SERVICE BULLETIN**Beech**

TITLE: **FUSELAGE - WING FORWARD SPAR CARRY-THRU STRUCTURE INSPECTION AND/OR REINFORCEMENT**

SYNOPSIS OF CHANGE

Figure 1

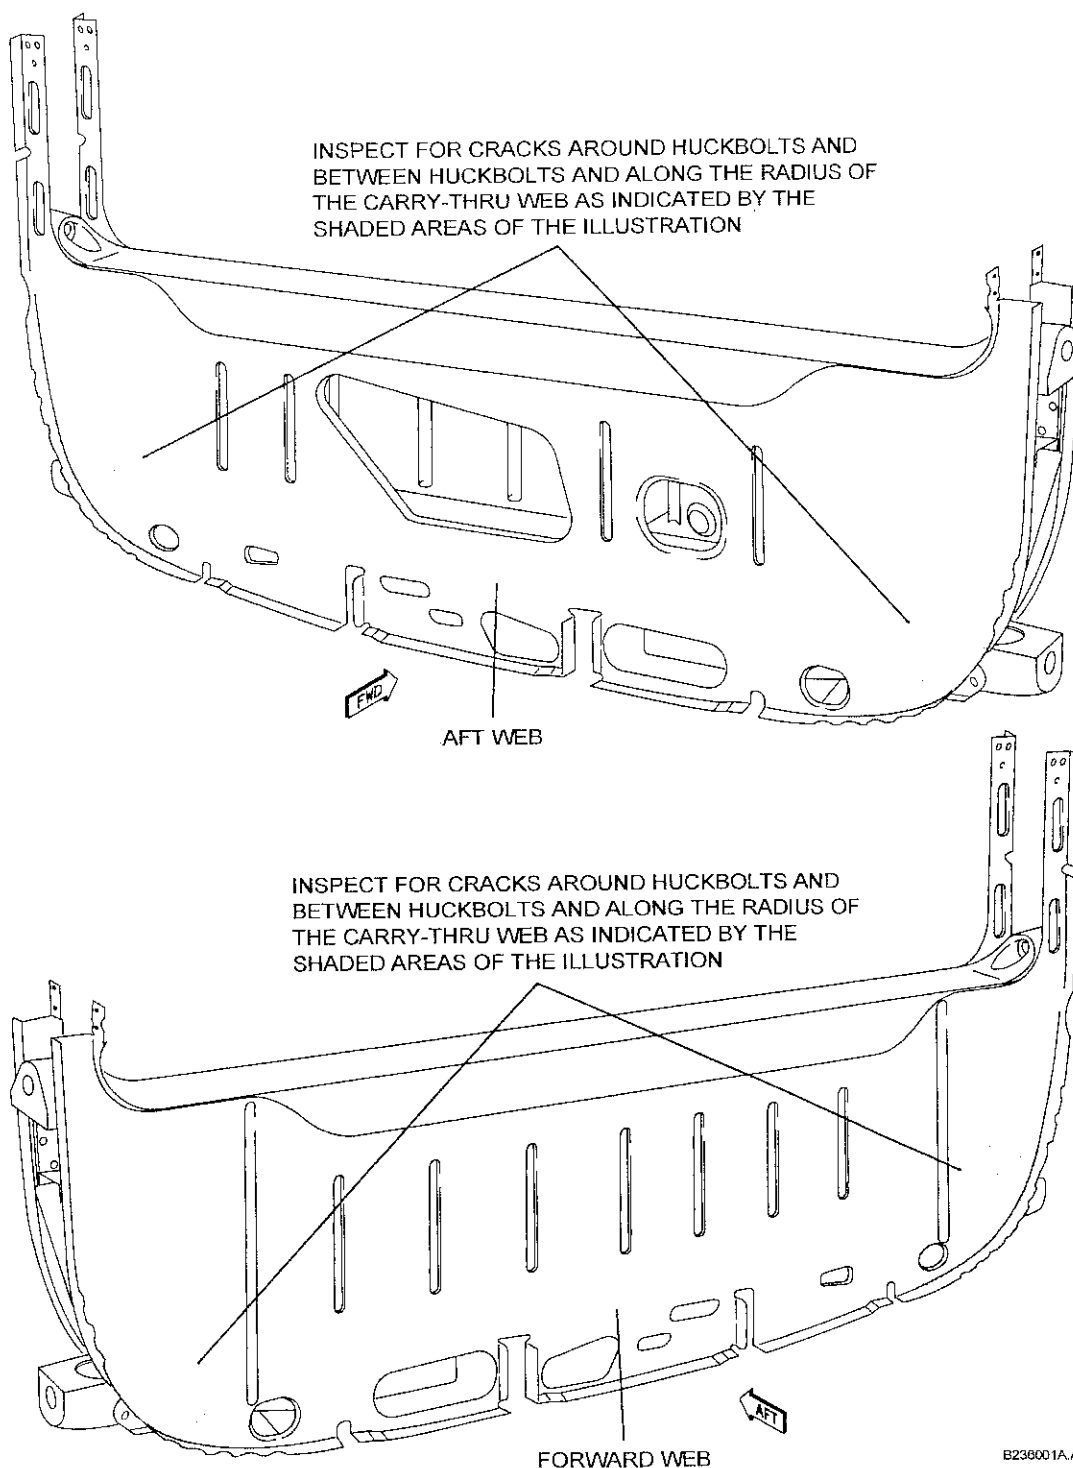
This Service Bulletin has been revised and is produced in the new format for Raytheon Aircraft Company Service Bulletins. Relevant technical changes are marked with change bars in the outside margins. The prior release of this Service Bulletin allowed for continued flight with known cracks that met specific criteria, and required a 500 flight hour recurring inspection. At the request of the Federal Aviation Administration (FAA), this Service Bulletin has been revised to remove the allowable crack limits that were permitted in the prior release of this Service Bulletin (SB No. 2360). If any crack(s) are discovered or are known to still be present from a previous inspection, this Service Bulletin revision requires that the crack(s) must be repaired by installation of the applicable P/N 36-4004 Kit(s) within the compliance times specified under ACCOMPLISHMENT INSTRUCTIONS in this Service Bulletin. If no cracks are discovered, this Service Bulletin revision continues to require re-inspection of the wing forward spar carry-thru structure forward and aft frames every 500 flight hours. The COMPLIANCE statement and ACCOMPLISHMENT INSTRUCTIONS for this Service Bulletin have been revised.

- (2) Remove the pilot's and copilot's seats and the carry-thru cover to obtain access to the front spar carry-thru structure.
- (3) Thoroughly clean the forward and aft frames (webs) of the front spar carry-thru structure in the shaded areas shown in Figure 1.
- (4) Perform a visual inspection of the area cleaned in step 3 for evidence of cracks.
- (5) Perform a dye-penetrant inspection, using visible dyes, of the area cleaned in step 3 for evidence of cracks.

Any of the shaded areas shown in Figure 1 that are modified by the installation of a doubler need not be dye-penetrant inspected until 1500 flight hours after the installation of that particular doubler. If no cracks are found, repeat the inspection every 500 flight hours.

Cracks found in the shaded areas of Figure 1 that have not been modified by a doubler must be repaired as indicated in this Service Bulletin on an individual basis.

The extent of repair is limited to cracking in the radius of the web flange and cracks in the web flat areas at the fasteners of the lower front spar cap.

- (i) A crack up to 4.0 inches in length shall be stop drilled at the ends using a #30 drill bit. The area is to be repaired per the applicable P/N 36-4004 Kit(s) within the next 100 flight hours, 12 calendar months or the next scheduled inspection whichever occurs first.
- (ii) A crack exceeding 4.0 inches in length shall be repaired PRIOR TO FURTHER FLIGHT per the applicable P/N 36-4004 Kit(s).

- (i) A crack emanating from one fastener in two directions is considered to be one crack. **Do not stop drill, due to the possibility of damaging structure behind web face.**
- (ii) Any crack shall be repaired per the applicable P/N 36-4004 Kit(s), within the next 25 flight hours, 12 calendar months or the next scheduled inspection whichever occurs first.
- (iii) A crack passing through two fasteners and extending beyond for more than 0.5 inch on either end shall be repaired **PRIOR TO FURTHER FLIGHT**, per the applicable P/N 36-4004 Kit(s).
- (iv) A crack passing through two fasteners and extending beyond for less than 0.5 inch on both ends shall be repaired per the applicable P/N 36-4004 Kit(s), within the next 25 flight hours, 12 calendar months or the next scheduled inspection whichever occurs first.

(c) If cracks are found in both the forward and aft frames on the same side of the airplane, in either the web face and/or the bend radius, and any of the cracks are more than 1.0 inch long, a repair shall be made **PRIOR TO FURTHER FLIGHT**.

(d) If cracks are found in both the forward and aft frames on the same side of the airplane, in either the web face and/or the bend radius, and all of the cracks are less than 1.0 inch long, a repair shall be made per the applicable P/N 36-4004 Kit(s) within the next 25 flight hours, 12 calendar months or the next scheduled inspection whichever occurs first.
